Re: Permanente Quarry, Mine ID # 91-43-0004
Application for Reclamation Plan Amendment (PLN 19-0106)
Response to July 22, 2019 Incompleteness Determination

Reference: Responses to SCC Incompleteness Determination for Permanente Quarry

Reference: Permanente Quarry – WMSA Slope Instability Remediation Plan

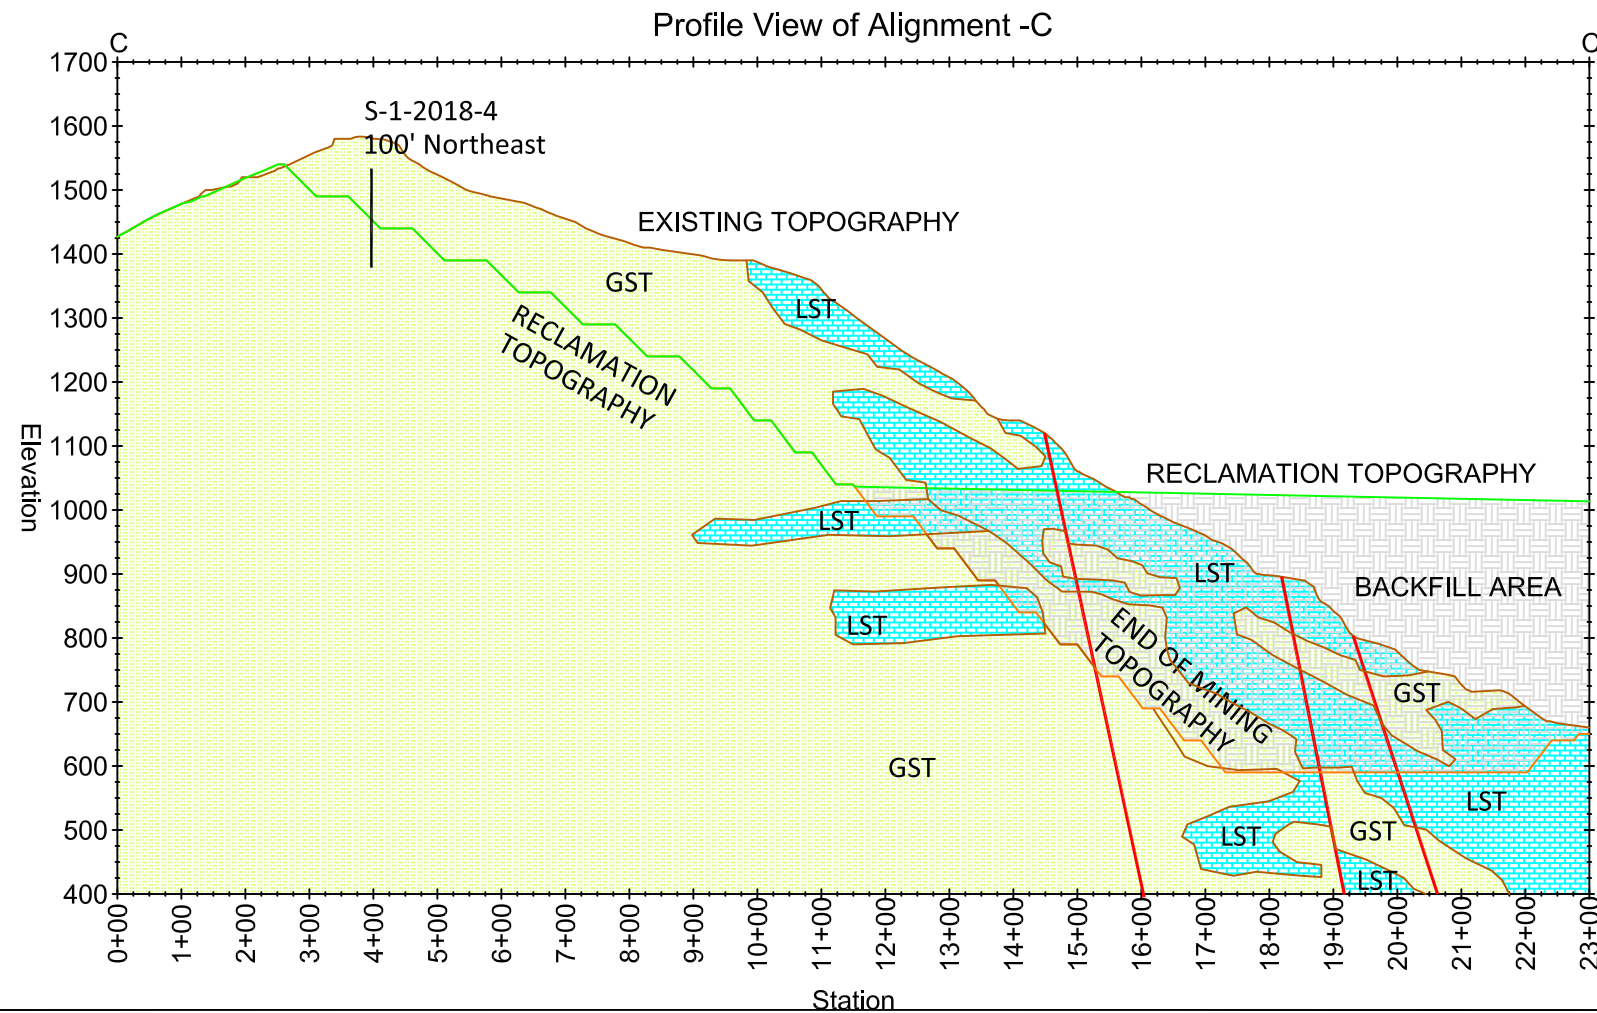
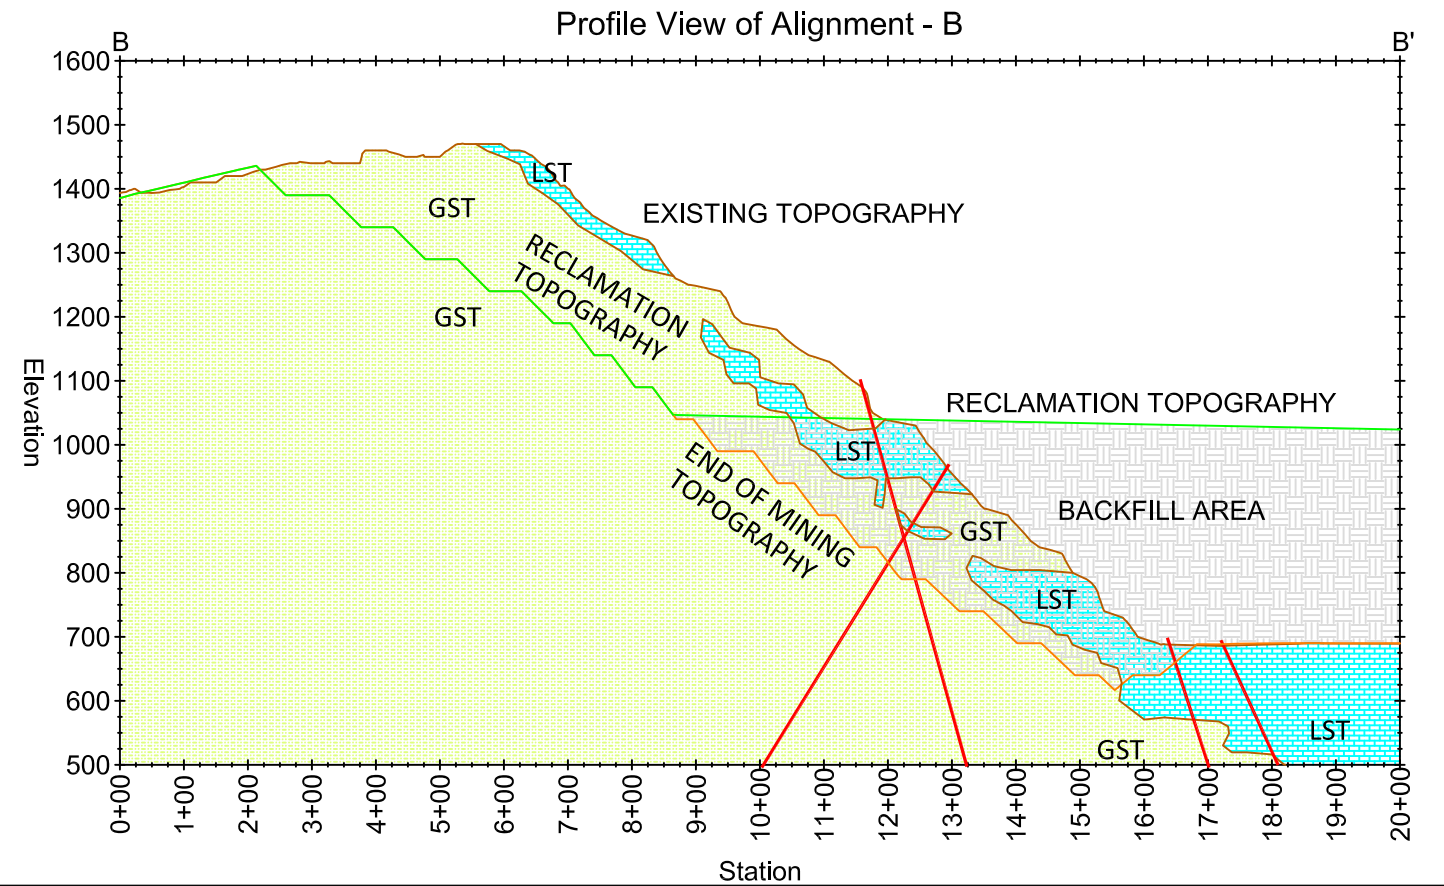
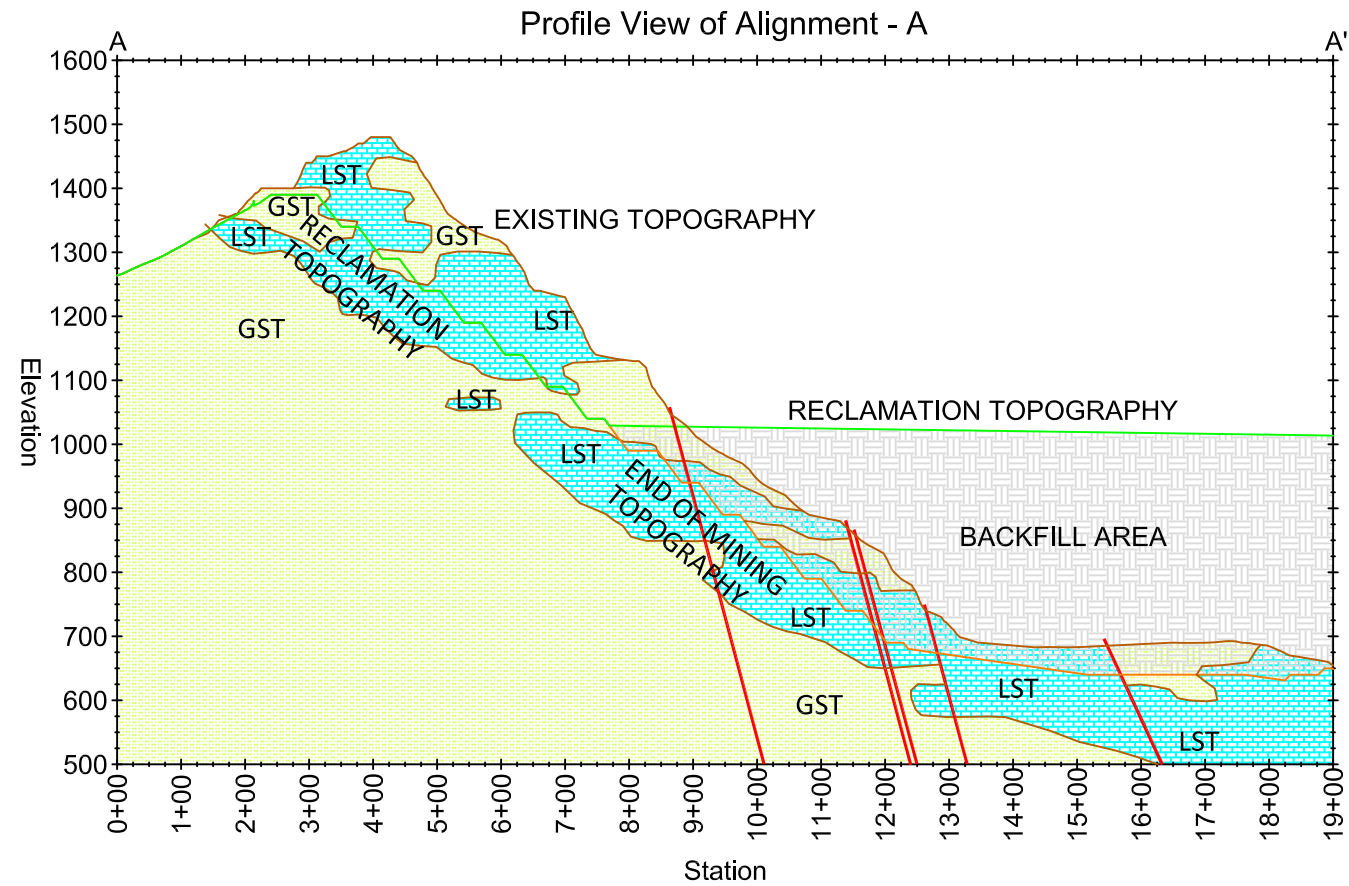
6. *Supplemental geologic/geotechnical evaluation (geologic cross-sections and slope stability calculations) of the long-term stability of the upper portion of the proposed cut slope on the west side of the Rock Plant Reserve (Sections A-A', B-B' and C-C'). The stability models must include the eastern edge of the existing (mapped) shear zone which also underlies the failing cut slope in the adjacent Stevens Creek Quarry. Unless better test data are available, utilize the same shear strength values determined there.*

II.E.6. Geology. Rock Plant Reserve Cross-Section

Stantec has revised the cross-sections associated with the Rock Plant Reserve Geotechnical Evaluation to include lithology, bedding planes, boreholes, and fault planes. These geologic data and the landslide in the

adjacent Stevens Creek Quarry were considered when preparing the mining and reclamation plans and were utilized in the slope stability analysis calculations. The revised cross-sections are included as Figures 3.4.

Title
North Highwall Reserve
Cross-Section

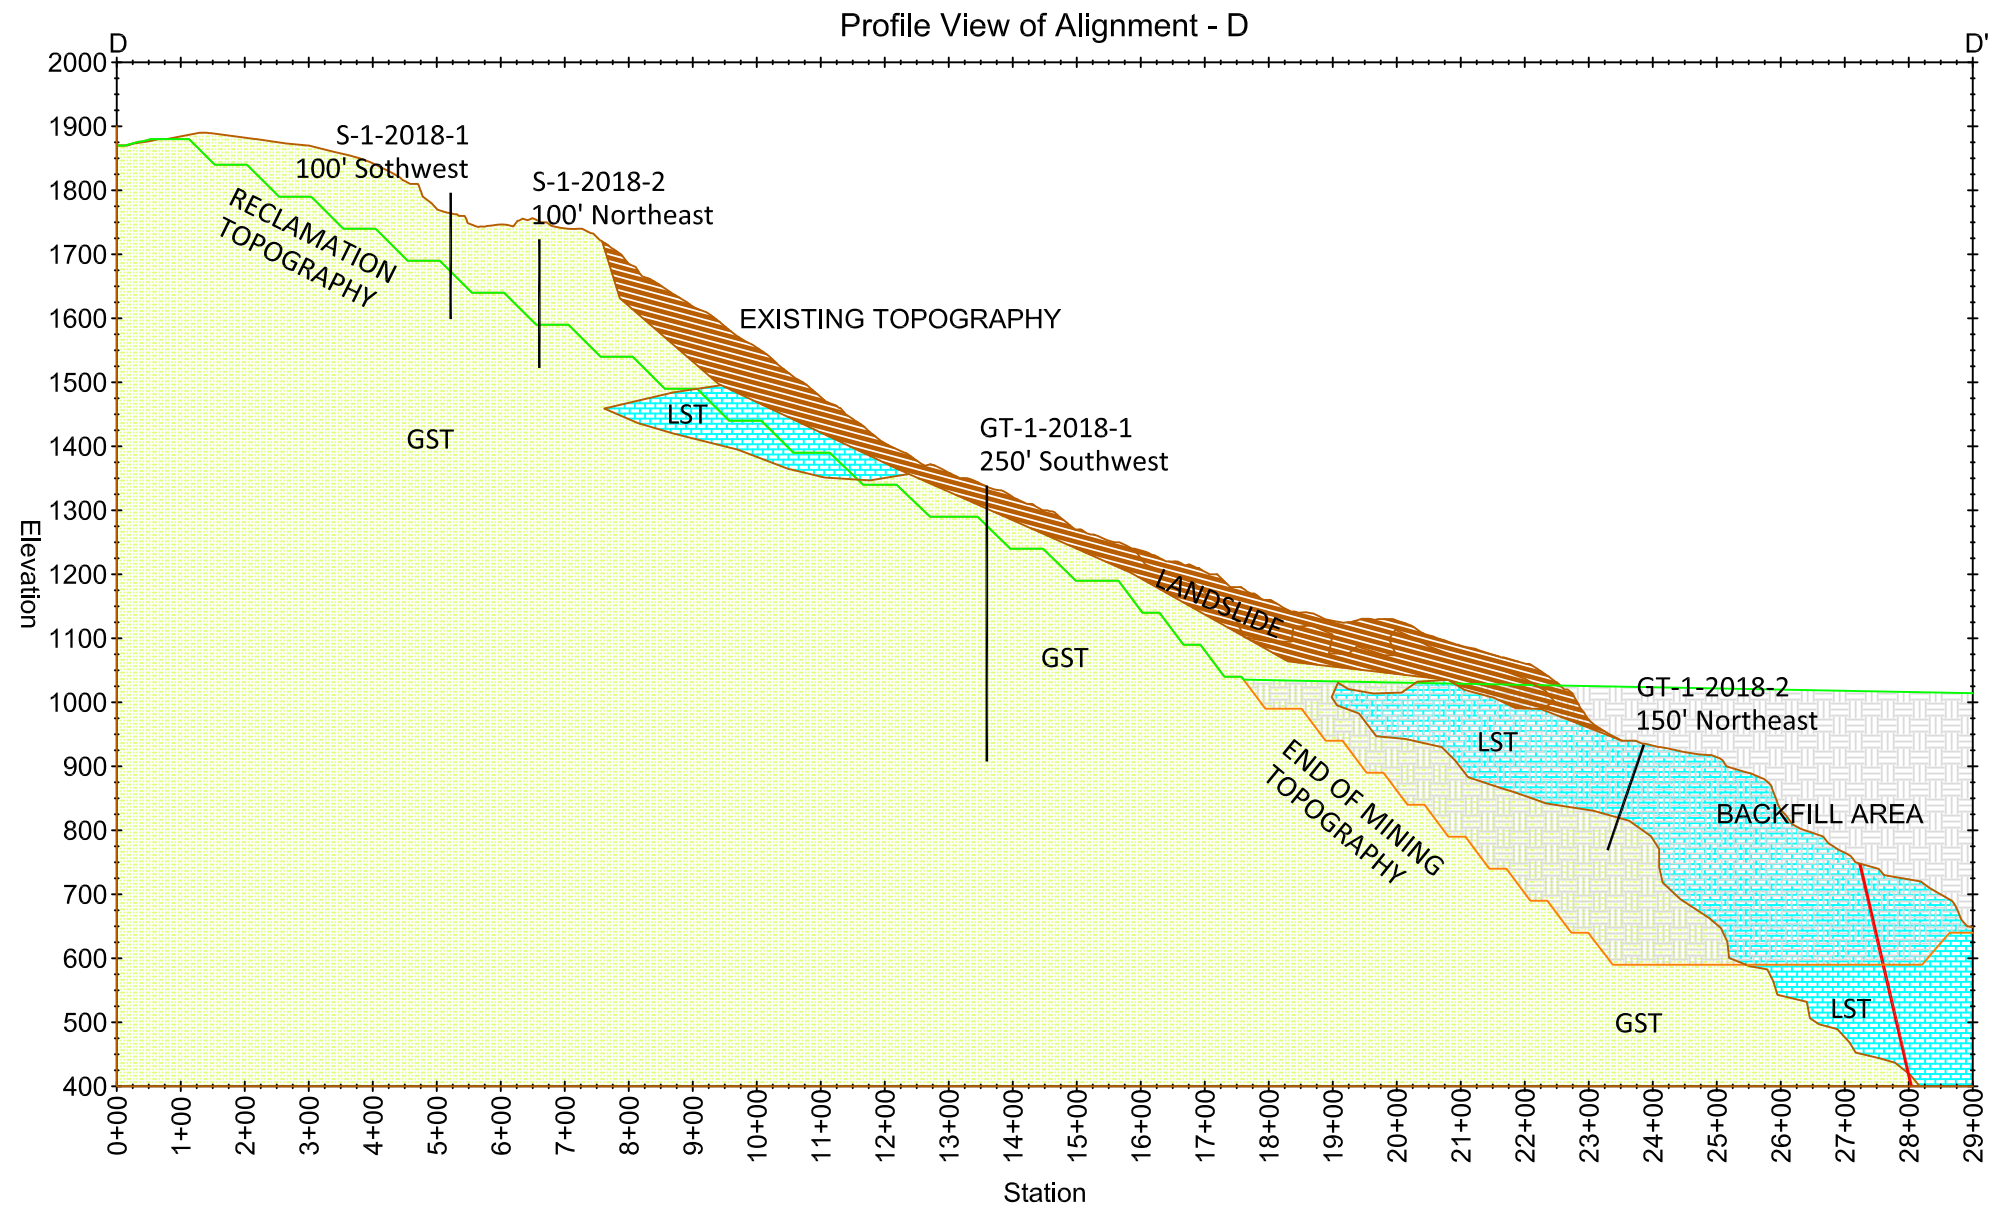
2. *Subsurface geologic interpretations (fault planes, bedding planes, etc.) need to be added to all of the cross-sections (e.g. Figure 3.3 in Binder 1, Appendix G) and the “models” used in the slope stability analysis (including the additional cross-sections and analyses referred to in the following comments #3 and #4).*

Stantec has revised the cross-sections associated with each of the geotechnical reports to include lithology, bedding planes, boreholes, and fault planes. These geologic data were considered when preparing the mining and reclamation plans and were utilized in the slope stability analysis calculations. The revised cross-sections are included as attachments to this memorandum. These figures include:

- North Highwall Reserve Figures 3.4 a, b, and c Cross-Sections
- North Quarry Backfill Figure 2.4 Cross-Section
- West Material Storage Area Figure 2.5 Cross-Sections
- Rock Plant Reserve Figures 3.4 Cross-Sections

Title
North Highwall Reserve
Cross-Section

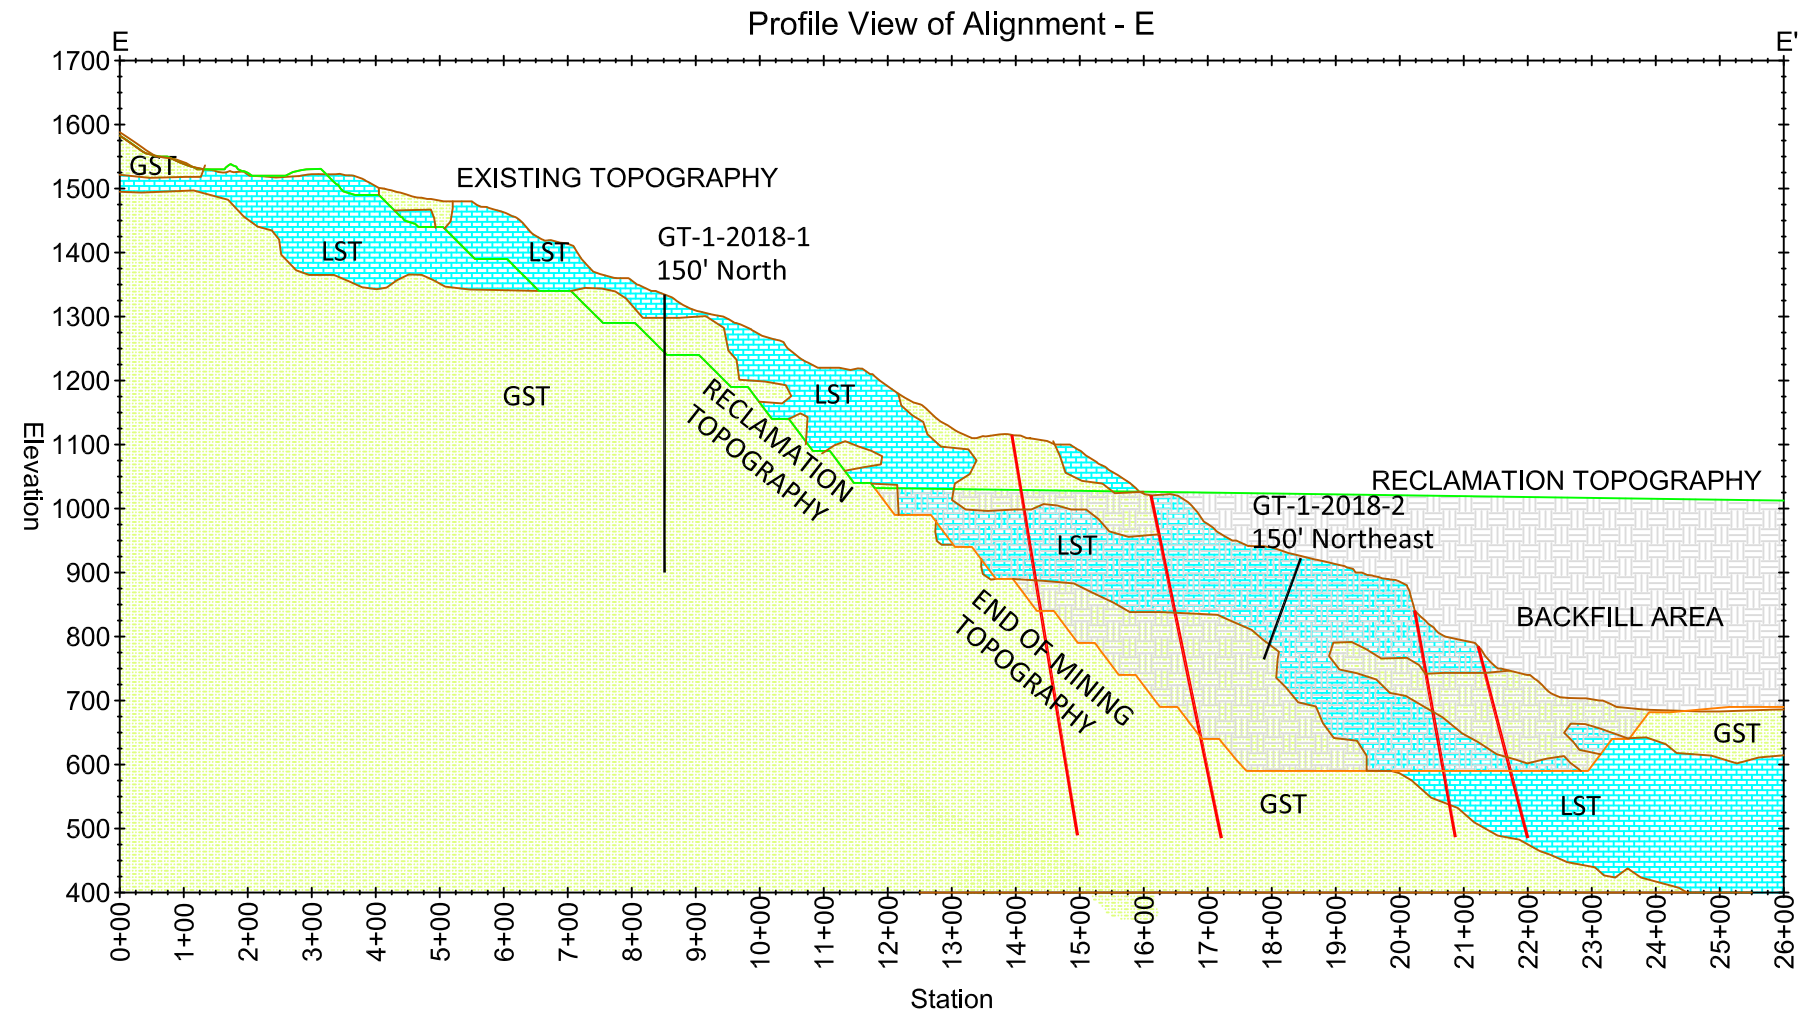
5. *Supplemental geologic/geotechnical evaluation (geologic cross-sections and slope stability calculations) of the long-term stability of the proposed "layback" of northwest highwall of the main pit (Section D-D'). The existing slide plane of the 1988 landslide must be shown and its shear strength considered in the analysis.*

Stantec has revised the cross-section associated with the northwest highwall and the historic landslide to include lithology, bedding planes, boreholes, fault planes, and the slide plane. These geologic data were considered when preparing the mining and reclamation plans and were utilized in the slope stability analysis calculations. The revised cross-section (D-D') is included as attached Figure 3.4b.
